AMENDMENT OF SOLICITATION/MODIFICATION OF CONTRACT				1. CONTRACT ID CODE <b>J</b>		PAGE OF PAGES <b>1</b>   <b>2</b>	
2. AMENDMENT/MODIFICATION NO. <b>0001</b>		3. EFFECTIVE DATE <b>28-Mar-2005</b>		4. REQUISITION/PURCHASE REQ. NO. <b>43445416</b>		5. PROJECT NO.(If applicable)

14. DESCRIPTION OF AMENDMENT/MODIFICATION (Organized by UCF section headings, including solicitation/contract subject matter where feasible.)							
This amendment is issued to incorporate a Revised Statement of Work. See attached Pages. The closing date remains 3:00 p.m., 18 April 2005.							
Except as provided herein, all terms and conditions of the document referenced in Item 9A or 10A, as heretofore changed, remains unchanged and in full force and effect.							
15A. NAME AND TITLE OF SIGNER (Type or print)				16A. NAME AND TITLE OF CONTRACTING OFFICER (Type or print)			
				TEL: _____ EMAIL: _____			
15B. CONTRACTOR/OFFEROR		15C. DATE SIGNED		16B. UNITED STATES OF AMERICA		16C. DATE SIGNED	
_____ (Signature of person authorized to sign)				BY _____ (Signature of Contracting Officer)		<b>28-Mar-2005</b>

## **N00174-05-R-0014 REVISED STATEMENT OF WORK**

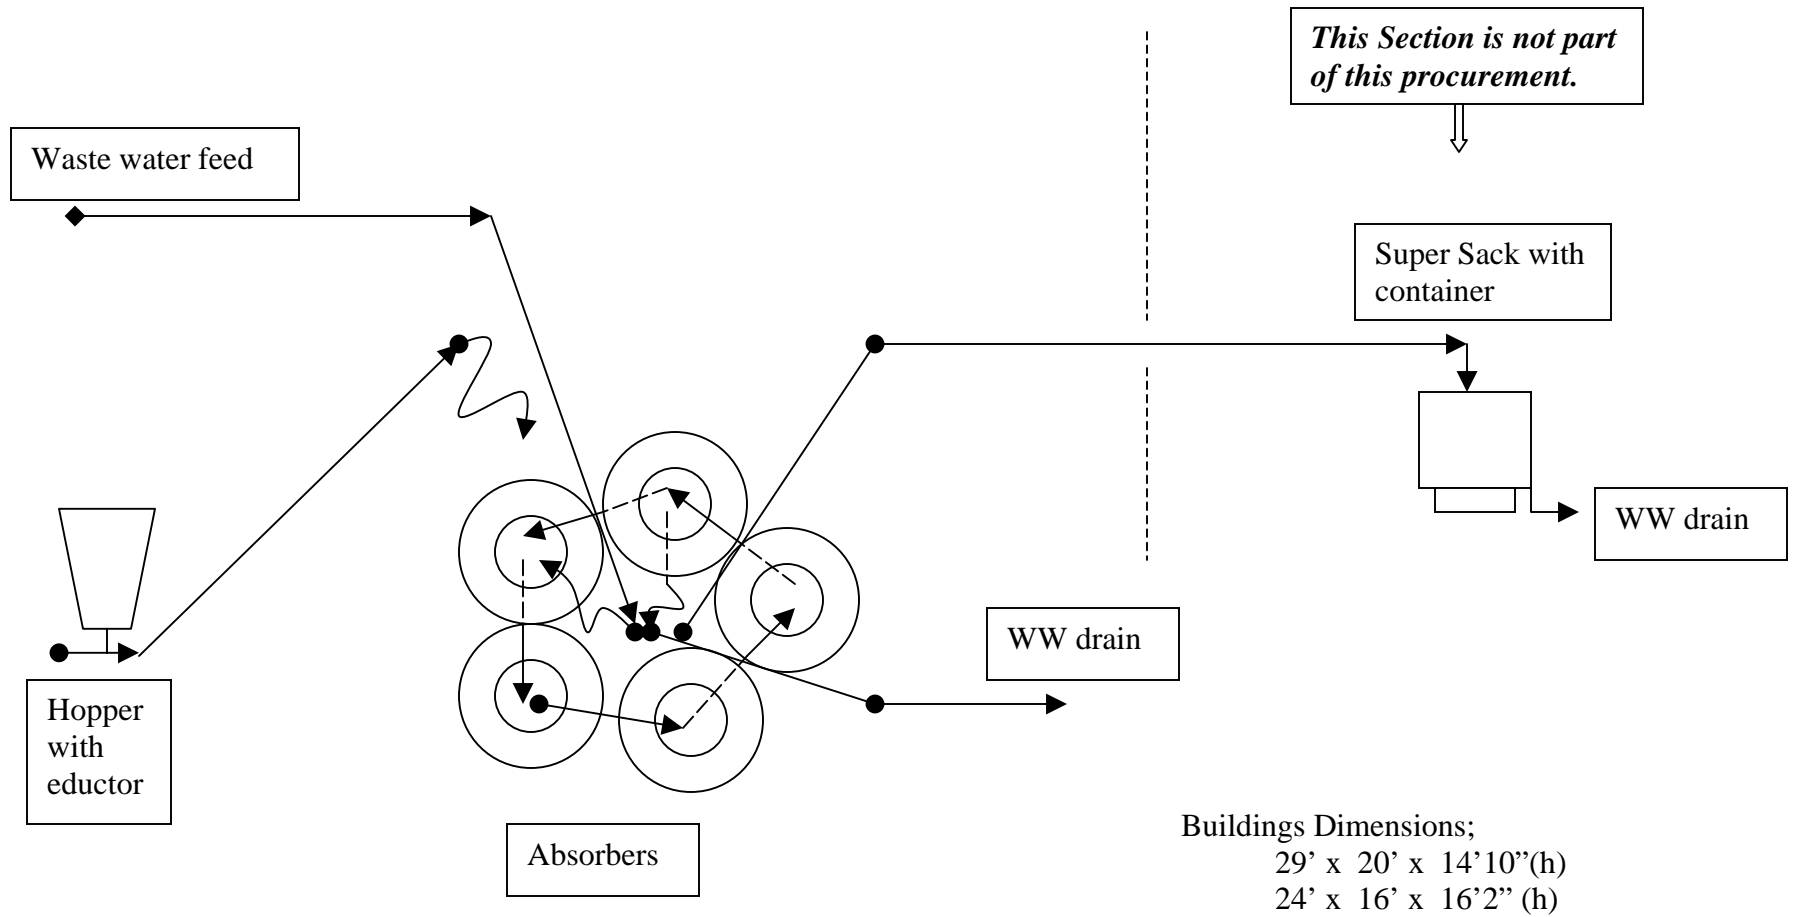
The outside diameter of the absorber could range between 30 to 33 inches with a minimum operating bed height of 24 inches. The current operating flow is 3 gpm per square foot. The absorber to have 36 inches straight side vertical height

The systems shall be rated to operate at a minimum 100 psig while permitting a throughput of 10 - 15 gpm. Provide appropriate pressure/vacuum relief vents. Fabricate the absorber with top and bottom dished head. The absorber must comply with the ASME code for pressurized vessel and stamped.

The absorbers shall provide a means of easily removing and dewatering the spent carbon and adding wet virgin carbon.

The absorbers shall be able to be lifted with a forklift. Provide lifting lugs.

Provide one (1) round bolted manway so the stainless steel internal(s) can be inspected and replaced, if necessary.
